# Access Compliance Report

## Public Rights-of-Way

### (Curb Ramps)

Intersection ID: 49125	Main Street: LEGOLAS_LN	Cross Street: LAVETA_RD	Location: NE
ADA ID: BE0B344B3246	Ramp Type: PerpDiag	Initial Pass/Fail: Fail	Overall Compliance: No
Severity Score: 13.75			
Codes/Mitigation Info/Possible Solution		Field Measurements/Component Compliance

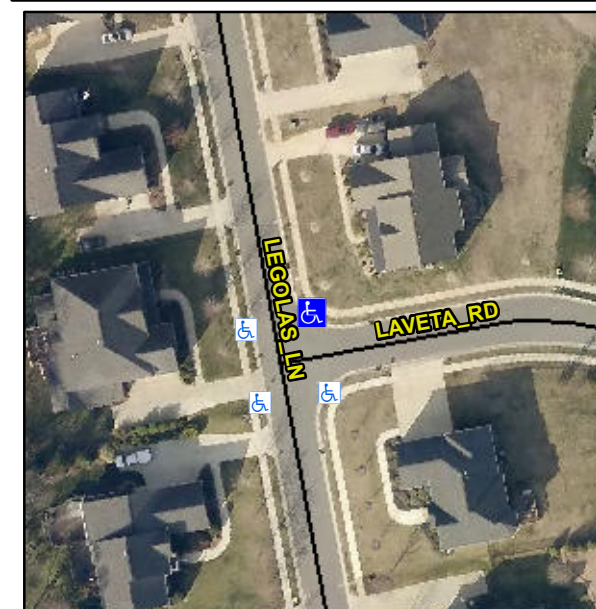
**Not Found, R304.2.2, R304.5.3**

Compliance	Description	Data	Compliance	Description	Data
N/A	Ramp Length (in)	47.0	No	Ramp Slope (%)	10.9
Yes	Ramp Width (in)	48.0	No	Ramp XSlope (%)	2.2
N/A	Flare Type LT	N/A	N/A	Flare Type RT	N/A
N/A	Flare Slope LT (%)	N/A	N/A	Flare Slope RT (%)	N/A
N/A	Flare Traversable LT?	N/A	N/A	Flare Traversable RT?	N/A
N/A	Landing Length (in)	N/A	N/A	DWS Provided?	N/A
N/A	Landing Width (in)	N/A	N/A	DWS Contrast?	N/A
N/A	Landing Slope (%)	N/A	N/A	DWS Length (in)	N/A
N/A	Landing X Slope (%)	N/A	N/A	DWS Full Width?	N/A
N/A	Landing Curb? (Y/N)	N/A	N/A	DWS Offset (in)	N/A
N/A	Shared Landing?	N/A			
N/A	Gutter Ponding?	N/A	N/A	Gutter Slope (%)	N/A
N/A	Gutter Lip Ht (in)	N/A	N/A	Gutter X Slope (%)	N/A
N/A	Painted X Walk1?	No	N/A	Painted X Walk2?	No
	X Walk 1 Direction	To W		X Walk 2 Direction	To S
N/A	X Walk 1 Width (in)	N/A	N/A	X Walk 2 Width (in)	N/A
	X Walk 1 Slope (%)	2.0		X Walk 2 Slope (%)	2.0
	X Walk 1 X Slope (%)	1.8		X Walk 2 X Slope (%)	0.8

**Remove & Replace Curb Ramp With Two New Directional Ramps or Equivalent.**
